PIC18FXX2 Rev. B3/B4 Silicon/Data Sheet Errata

The PIC18FXX2 Rev. B3/B4 parts you have received conform functionally to the Device Data Sheet (DS39564B), except for the anomalies described below.

The following silicon errata apply only to PIC18FXX2 devices with these Device/Revision IDs:

FIGURE 1: PINOUT DIAGRAM FOR PIC18F442/452, 44-PIN QFN PACKAGE

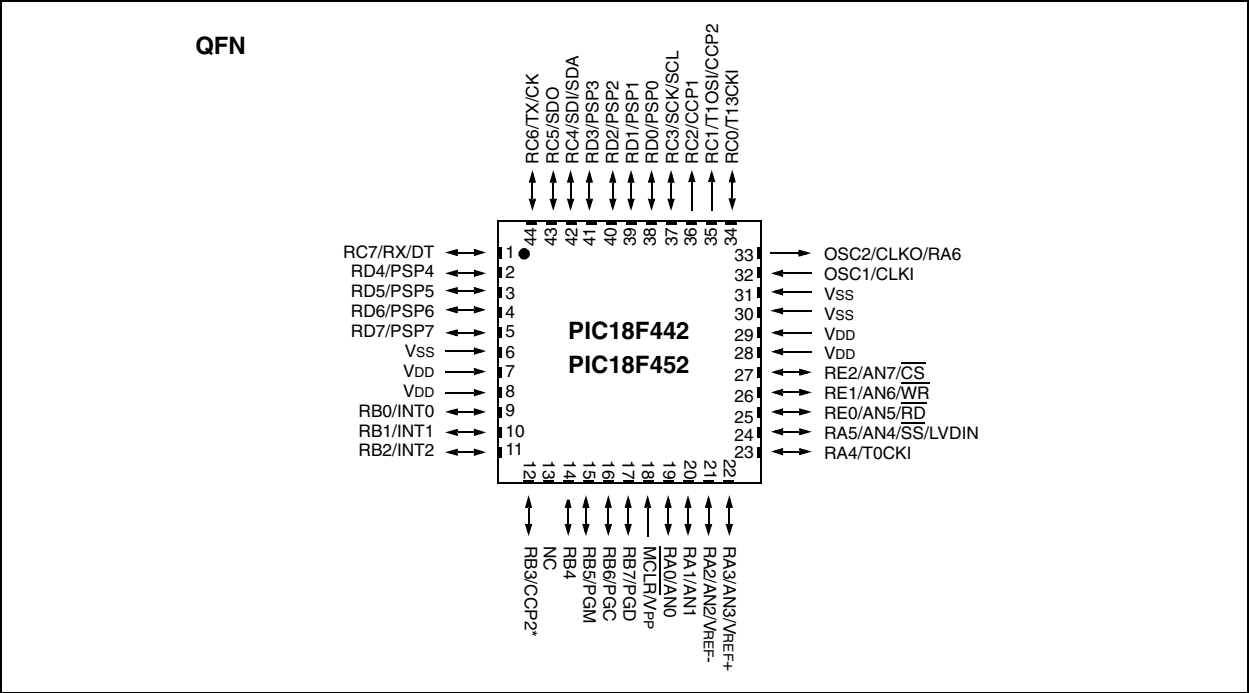
- 1. The “Pin Diagrams” on pages 2-3 of the Data Sheet are amended with the addition of the 44-pin QFN pinout, shown in Figure 1.
- 2. Table 1-3 of Section 1.0 “Overview” is replaced with an updated version which adds a column for QFN pin assignments. A row is also added for previously unlisted NC pins. All new information is indicated in **bold**.

FIGURE 2: PACKAGE MARKING TEMPLATE FOR PIC18F442/452, 44-PIN QFN

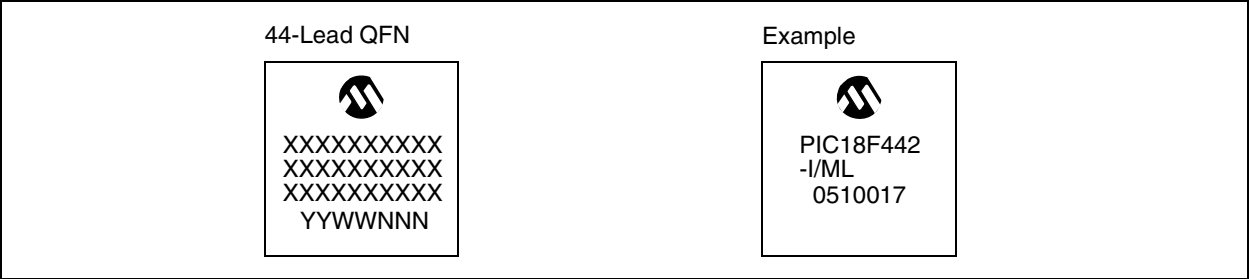
- 3. Section 24.1 “Package Marking Information” is amended to include a marking template and example for 44-pin QFN devices. These are shown in Figure 2.

FIGURE 3: 44-PIN QFN PACKAGE

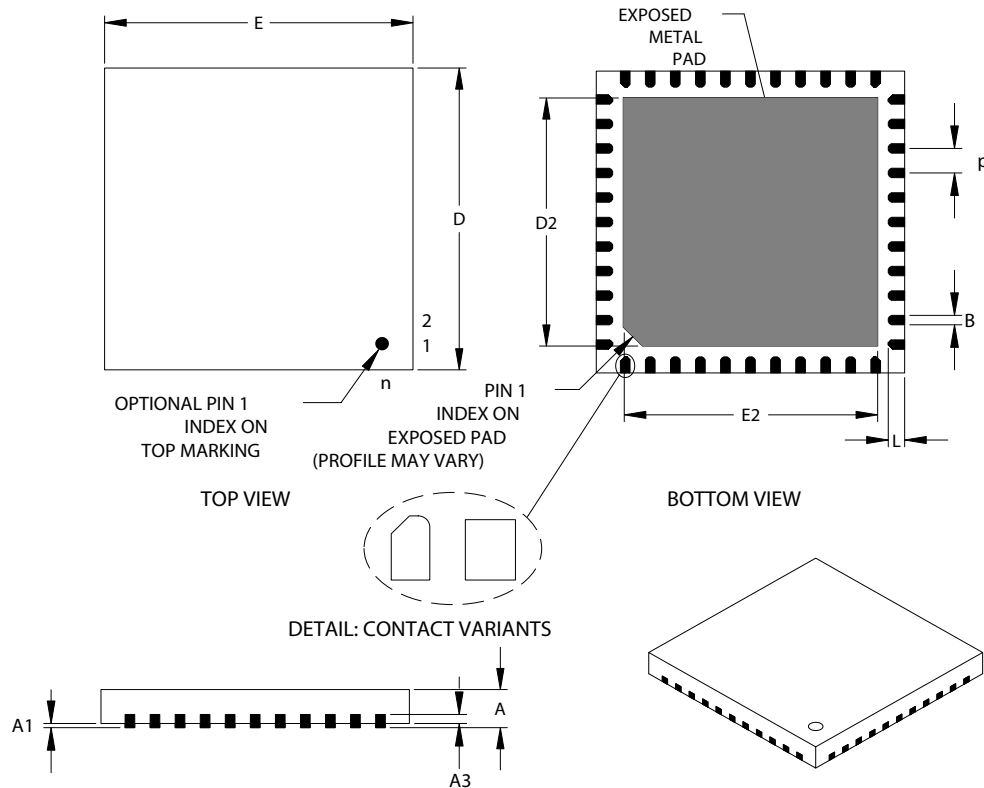
- 4. Section 24.2 (Package Details” is amended to include the mechanical drawing of the 44-pin QFN package following the existing drawings, shown in Figure 3.
